TECHNICAL SERVICE BULLETIN

ITEM T81/08

SUBJECT: AC DELCO ELECTRONIC IGNITION COIL/MODULE

MODELS: TR7 (from engine #CV30570)

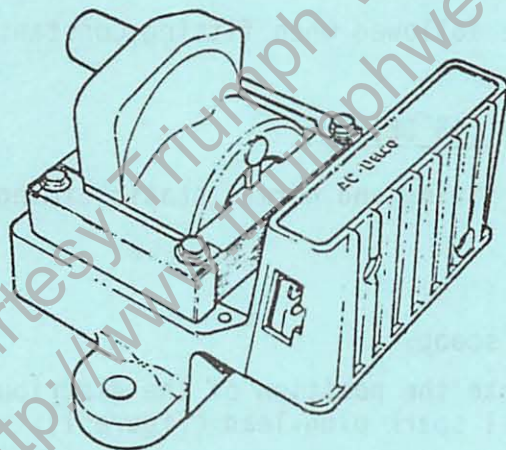
The electronic ignition module fitted into the heat sink on the ignition coil assembly is available as a separate unit. The part number for the module is JRT 601011.

Complete coil assemblies must not be replaced for suspected failure of the module.

Technical Service Bulletin T80/025 issued in Sept/Oct 1980 refers to intermittent ignition failure due to poor connections in the moulded plug. The plug and connections must be thoroughly checked before assuming the module to be at fault.

Operation 86.35.35 - Remove/Replace Ignition Module - 0.40 hours
